**RESPONSE COMMENTS OF
NORTHERN INDIANA PUBLIC SERVICE COMPANY LLC
TO STAKEHOLDER COMMENTS ON
NIPSCO'S 2018 INTEGRATED RESOURCE PLAN**

SUBMITTED: April 30, 2019

¹⁹ The graphic is sourced from the annual revenue requirements summarized for Portfolios 1 and 6 in the "Rev Req Components-Retirements" tab in Confidential Appendix D to the 2018 IRP.

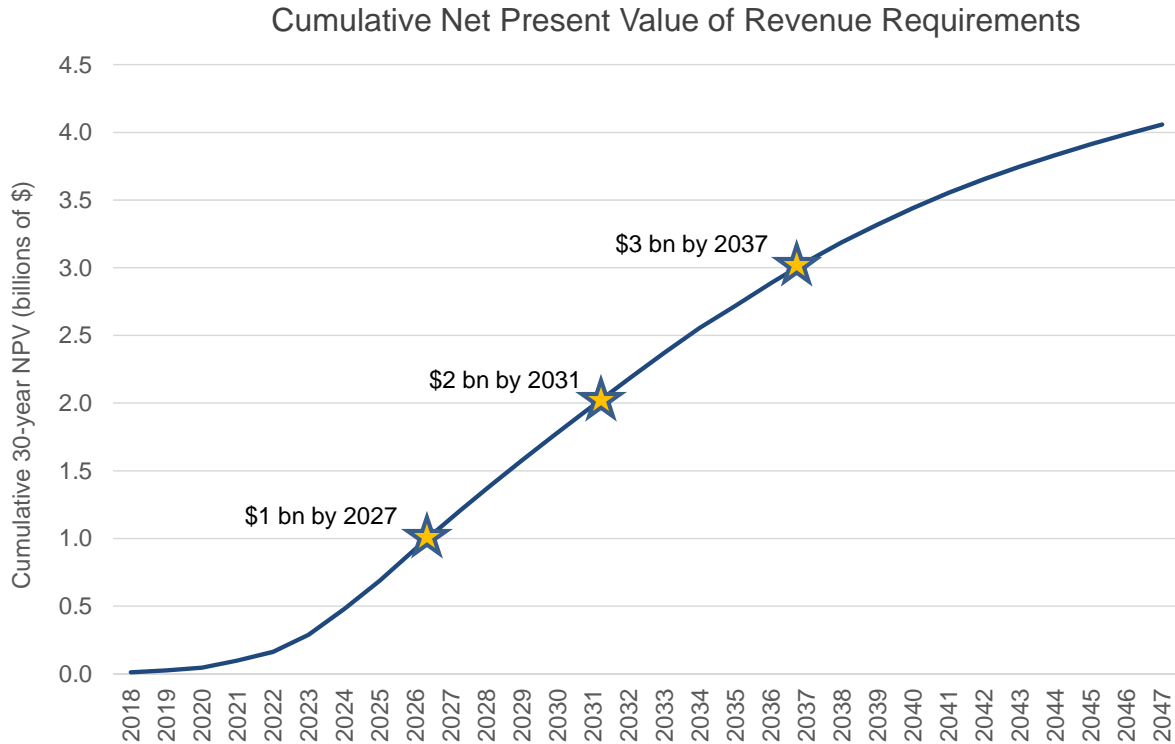
Throughout its comments, the ICC stated that rate impacts were not considered by NIPSCO. However, NIPSCO produced annual revenue requirement projections, which were included for all scenarios and portfolios within the IRP. In all of the scenarios, the preferred portfolio with early coal retirement has lower annual revenue requirements than portfolios that retain coal longer. The ICC's claim that coal retirements would introduce rate shocks is false, and NIPSCO's analysis has shown that retiring coal plants early provides savings in all years. This is demonstrated in the graphic below, which provides the cumulative net present value of revenue requirement savings between Retirement Portfolios 1 and 6 over time.¹⁹ The projected residential rate increases associated with customer class cost allocation considerations in NIPSCO's active rate case proceeding is separate from the resource planning decisions evaluated in the IRP. ICC's efforts to conflate the two is misleading and inaccurate.

For overall summary presentation of results, the net present value of revenue requirements is a valid way to summarize the rate impacts over the planning period and is the metric used in NIPSCO’s scorecard. This is supported by the CAC comments, which state “[i]t is very likely to be very cumbersome to translate revenue requirements in an IRP into specific rate impacts by rate class because of the complexity of cost allocation. Therefore, the focus is normally on net present value of differing portfolios as a proxy for rate impacts.”²⁰ The CAC indicates that NIPSCO met the requirements of the IRP rule.
